## Aftersales Bulletin

### 00 51 44 05 00 – Service Action Comfort Entry Access Deactivation

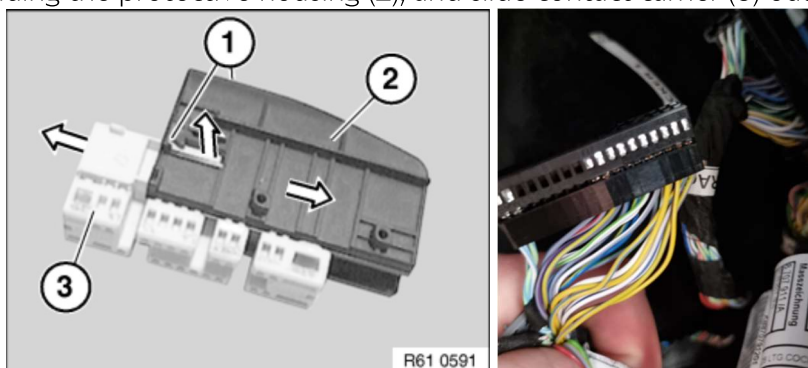
1. Access the Body Domain Controller by removing the front right A-pillar side panel, please refer to REP: 51 43 075 Remove and install side trim panel, footwell, on A-pillar right .
2. Disconnect Plug connector A258\*9B from the BDC control unit.

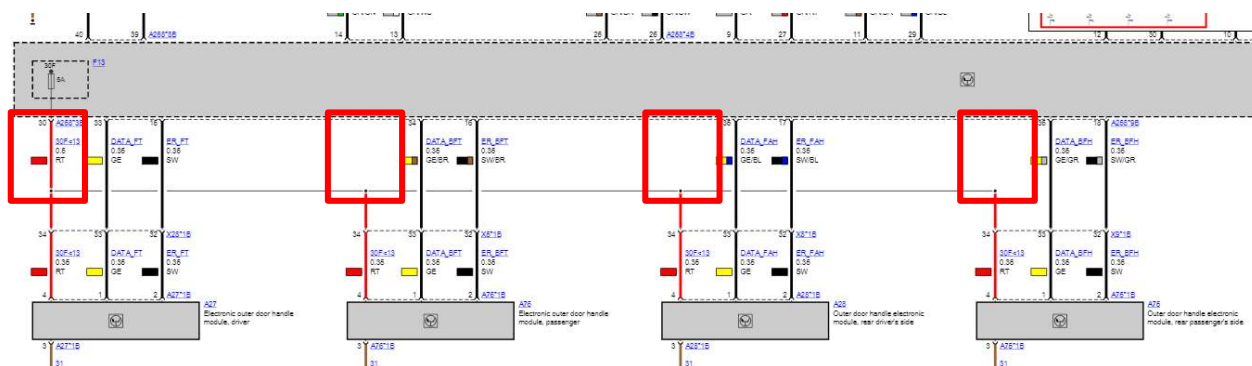
3. Remove socket housing protective cap by pressing locking tabs (1) in an upwards direction, and sliding the protective housing (2), and slide contact carrier (3) outwards.

4. Remove the following pin contacts:
  - a. 33 (GE) – yellow
  - b. 34 (GE/BR) – yellow & brown
  - c. 35 (GE/BL) – yellow & blue
  - d. 36 (GE/GR) – yellow & grey

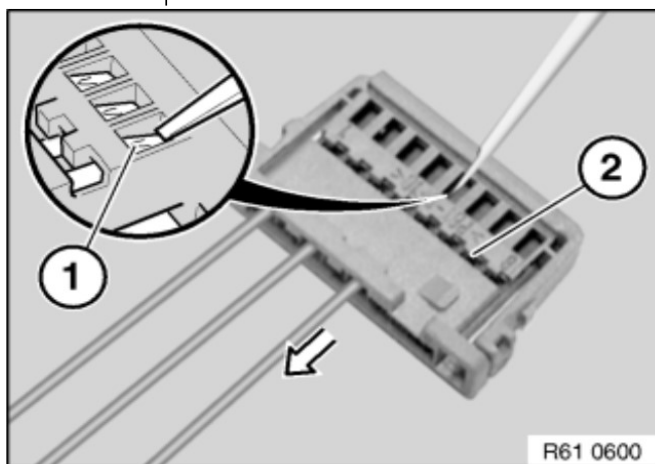
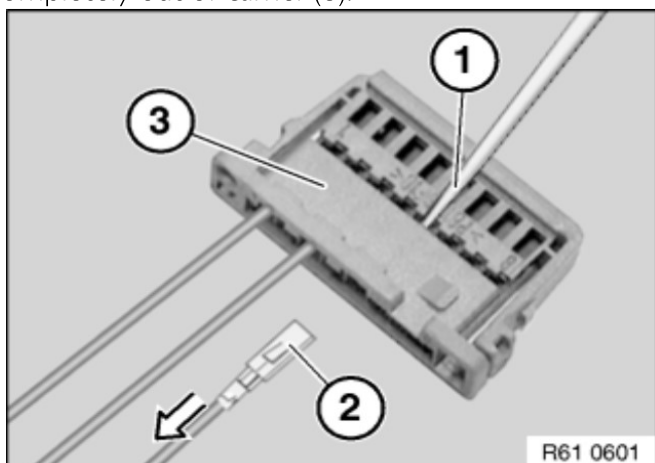
Note! Connector shown below in the next 2 pictures are for illustration purposes only. Hold down retaining hook (1) of pin contact in opening of carrier with a small screwdriver. Gently pull wire with pin contact in direction of arrow as far as secondary lock (2).

Hold down retaining hook in secondary lock (1) again and gently pull wire with pin contact (2) completely out of carrier (3).

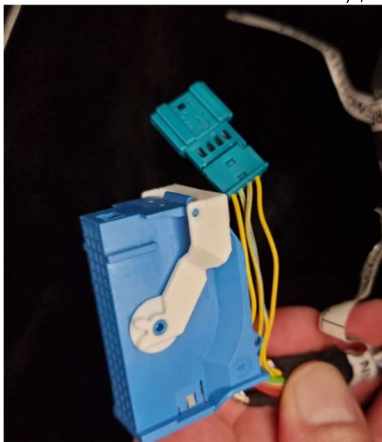
- Fit the removed pins into 4 pol connector 61 13 2 359 994, or alternative MQS connectors. Pictures are for reference only; the color of the connector may be different.
